**Central District Office**

**Re: Construction Storm Water Inspection at COTA Fields Avenue Paratransit Facility  
Franklin County  
Permit Number 4GC03003\*AG**

Figure 1: Silt fence along Fields Avenue must be repaired

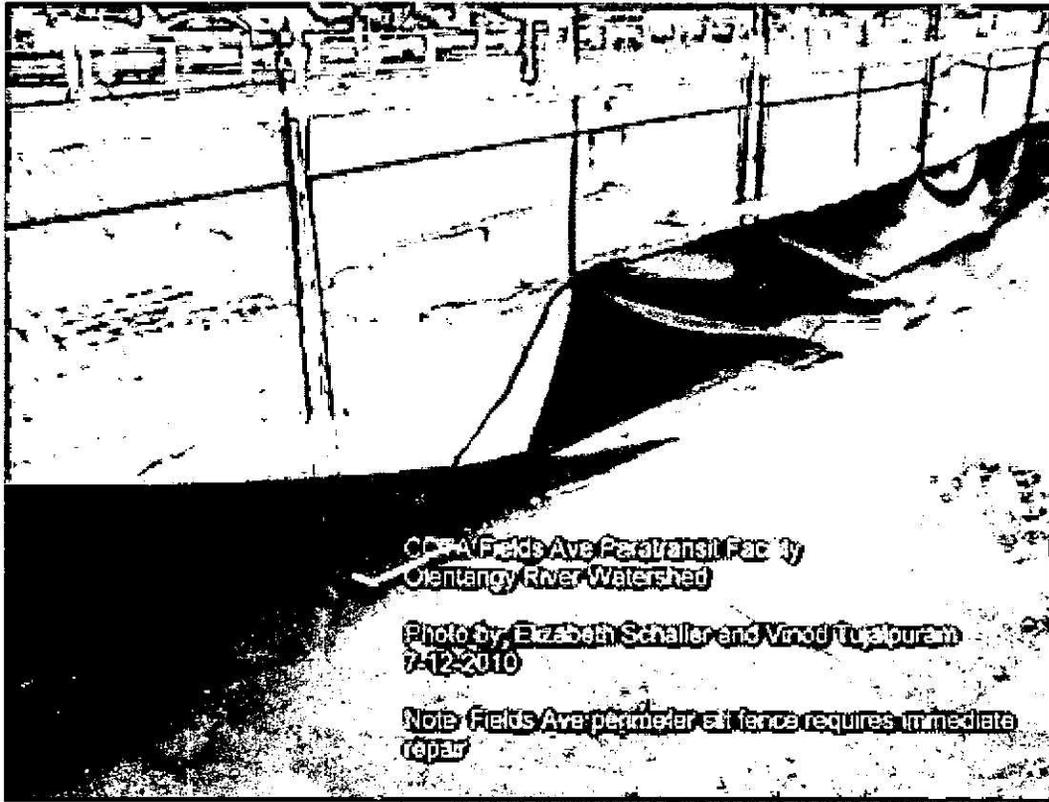
- The silt fence on the Fields Avenue side of the site has failed and will require maintenance at this time.
- The sediment basin for this site appears to be functioning as intended. Please be aware the general permit states that all sediment controls will be inspected and maintained every seven days or within 24 hours of a precipitation event equal to or greater than 0.5 inches to ensure continued effectiveness of the sediment basin.
